Office Action Summary	Application No. 10/518,331	Applicant(s) WIXEY ET AL.	
	Examiner Amadeus S. Lopez	Art Unit 3771

DETAILED ACTION

Figure 1

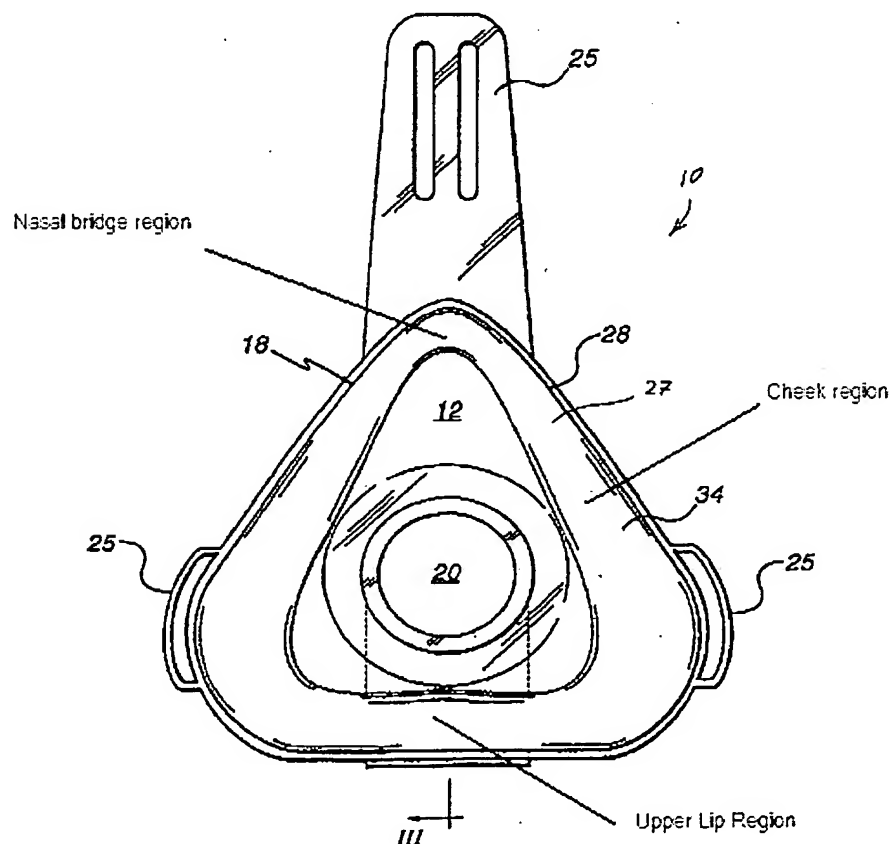
As to claims 2-4, Scarberry et al discloses a sealing interface wherein the inner sealing member has a cut out region in the nasal bridge region, in the cheek region, and the upper lip portion (labeled in figure 1 shown below).

As to claim 5, Scarberry et al discloses a sealing interface wherein the inner sealing member and the outer sealing member are continuously in contact both in use and when not in use around the facial contour contacting region (see figure 1 wherein 28 and 34 are continuously in contact).

Figure 2

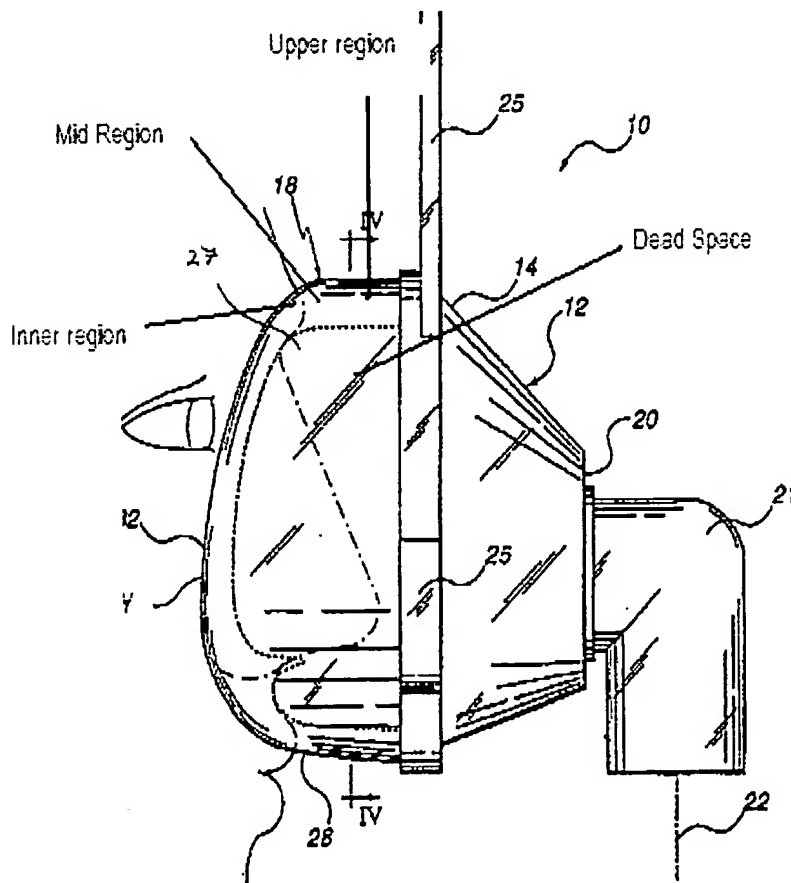
As to claim 9, Scarberry et al discloses a sealing interface wherein the nasal bridge region comprises an inner region, a middle region and an outer region whereby in use the inner region is most proximate the user (labeled in figure shown below).

As to claim 10, Scarberry et al discloses a sealing interface 9 wherein the inner region, the middle region and the outer region comprise dead space (figure 2 above shows that the disclosed regions comprise dead space within the mask labeled in the figure).
